दिल्ली विकास प्राधिकरण

Ref. Draft Minutes of T-Committee Meeting held on 26.11.90.

DRAFT MINUTES OF THE TECHNICAL COMMITTEE MEETING TO
BE HELD ON 26.11.90 AT 9.30 A.M. IN THE CONFERENCE
ROOM OF VIKAS MINAR AT 5TH FLOOR, DELHI DEVELOPMENT
AUTHORITY

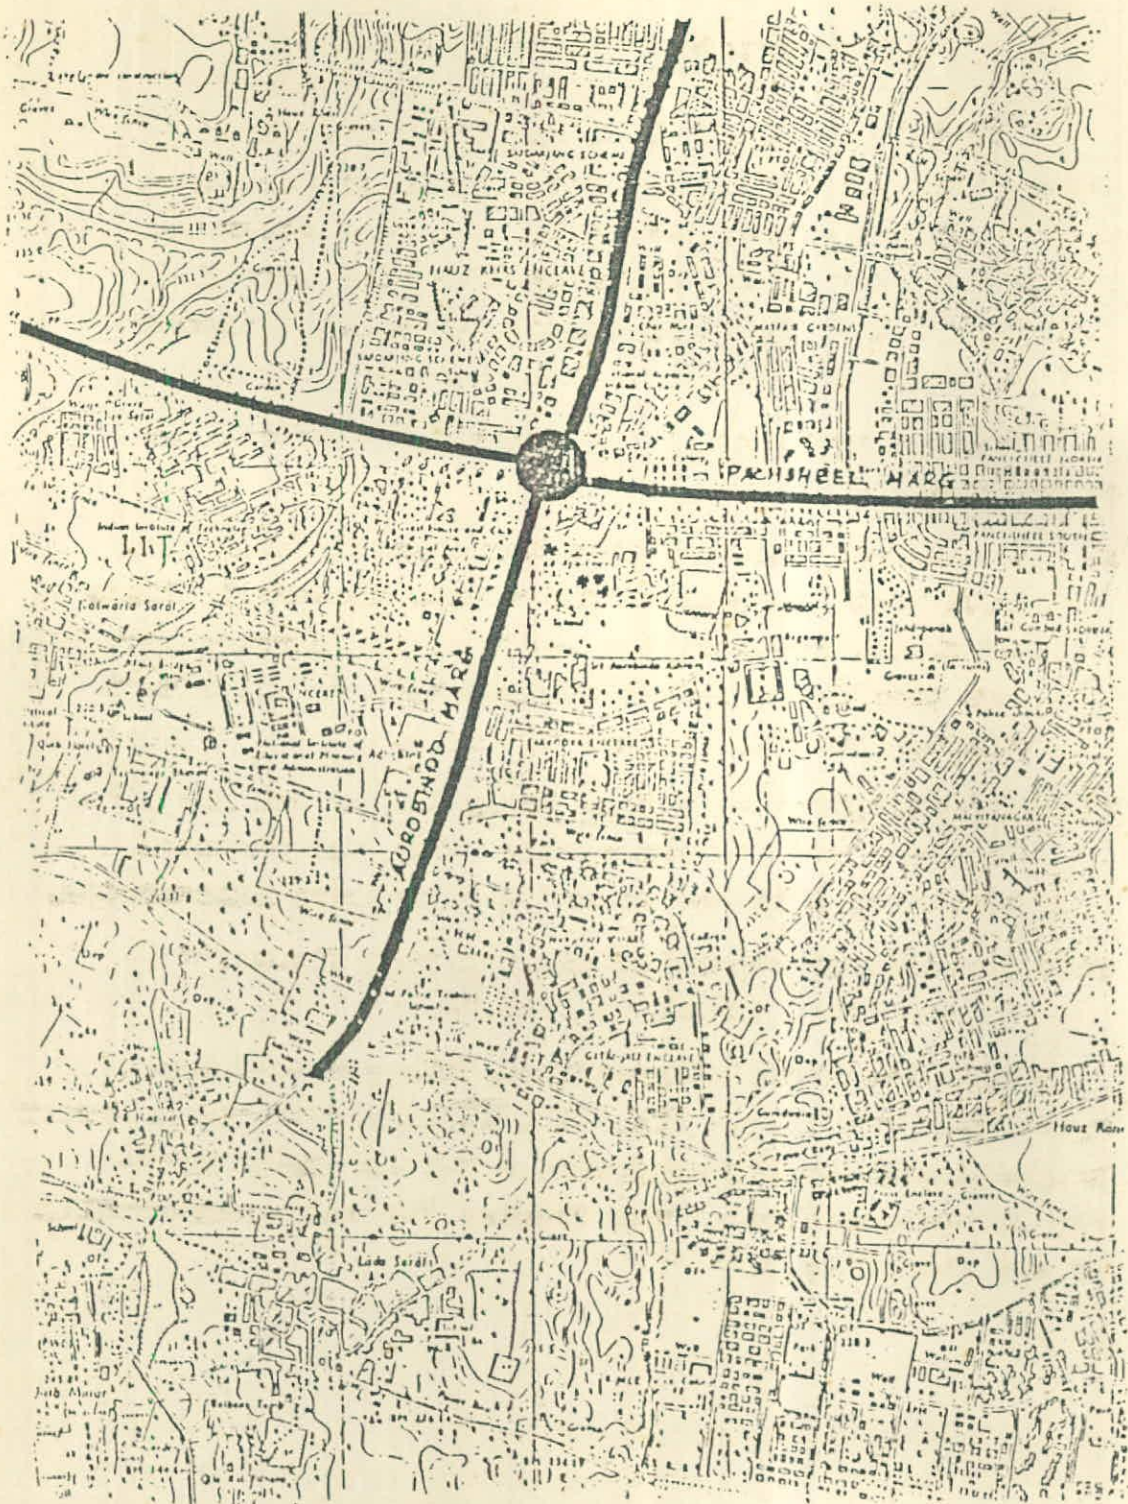
The observations of the Technical Committee are as under:-

- i) Consultant informed that the separate slip Road could not be provided due to the non-availability of space, however, the width of the carriageway has been increased at the junction to allow left turning traffic to pass smoothly.
- ii) The circulation of Hauz Khas, I.I.T. and Bus Terminal area be integrated with the proposed circulation in and around the proposed interchange.
- iii) Feasibility report of the proposed flyover to be submitted to DDA by LTLC.

With the above observations, the proposal was agreed in principle. (The DTLC shall submit the modified proposal with DUAC's approval, model and feasibility report and 9 copies of the drawing for the consideration of the Authority.).

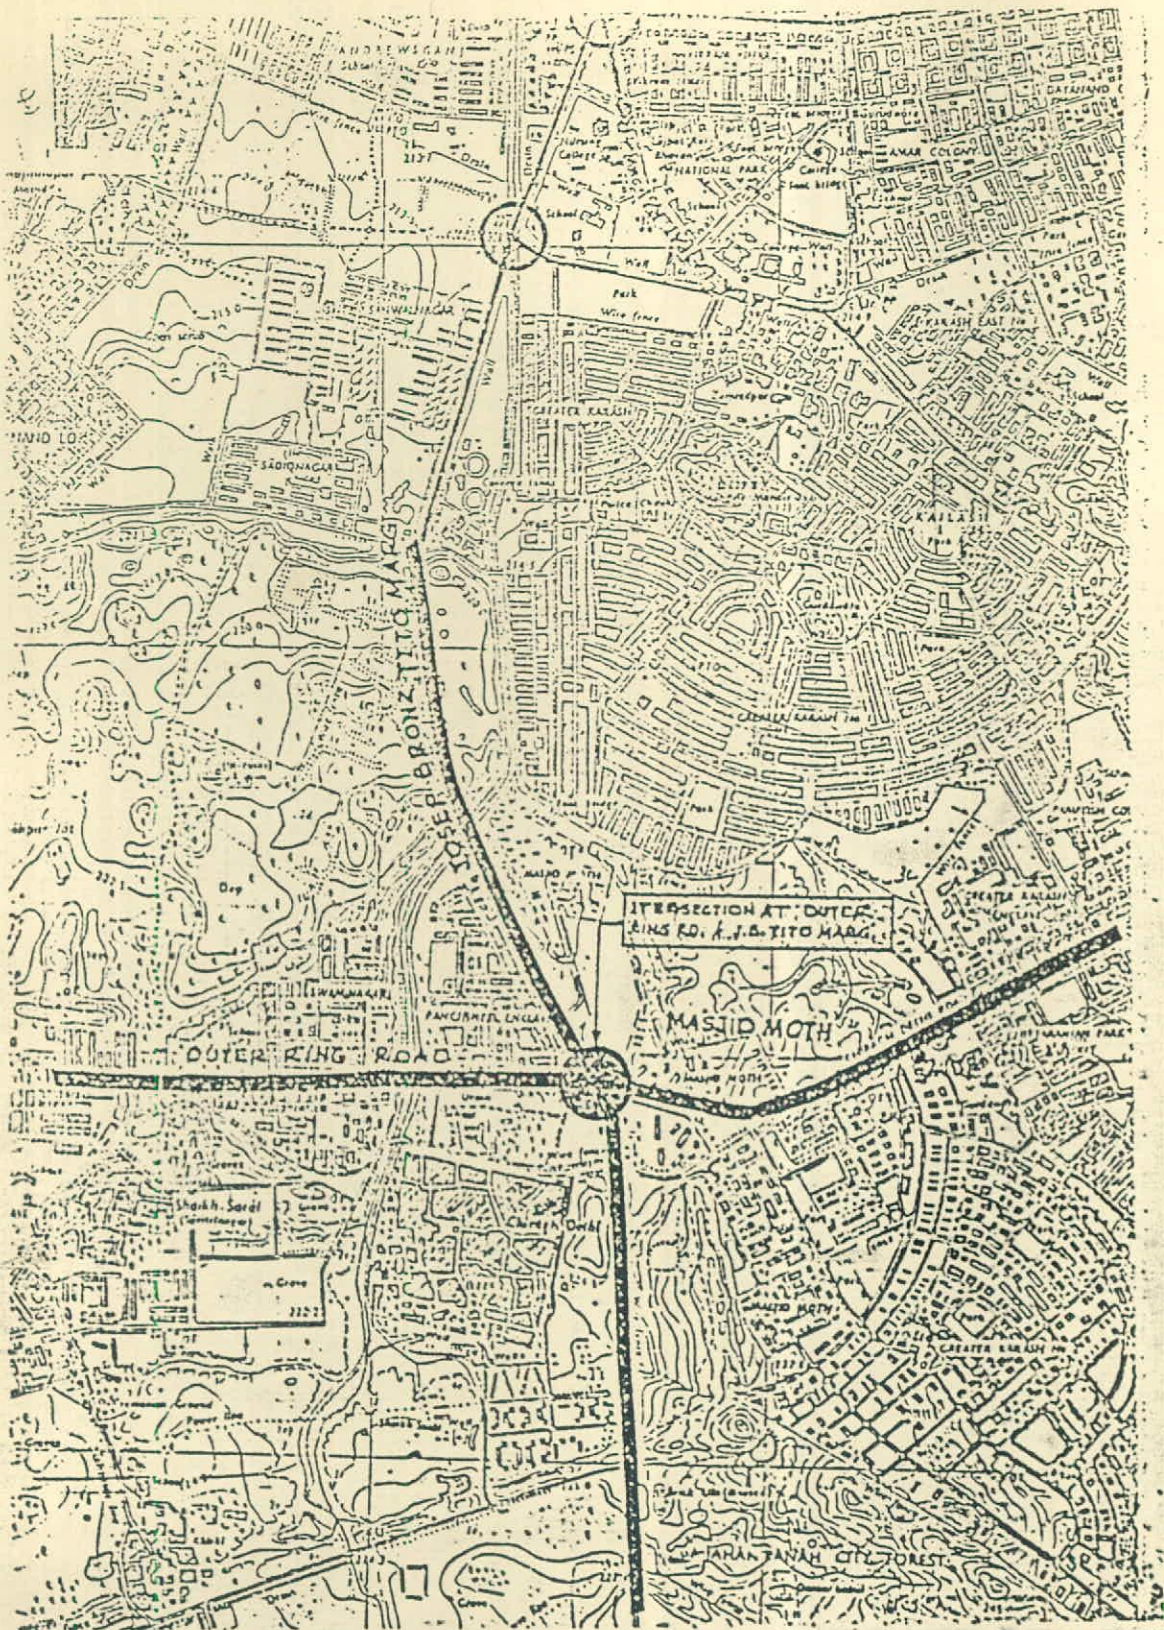
The traffic circulation has been indicated on key plan identified for the flyover proposal.

The following intersections has been identified for improvement in connection with flyover proposal.

- i) Improvement Scheme for Outer Ring Rd. & G.K.II Road intersection (Near Savitri Cinema) Agency-MCL.
- ii) Proposed improvement for Khel Gaon Marg Outer Ring Road intersection (by covering two 'T' intersection into one four arm intersection scheme prepared by MCL).
- iii) 'T' intersection of Rd.No.15 with Lal Bahadur Shastri Marg. Agency-MCD.
- iv) Intersection of J.B.Tito Marg with the Rd. leading to Archana Cinema - Agency.
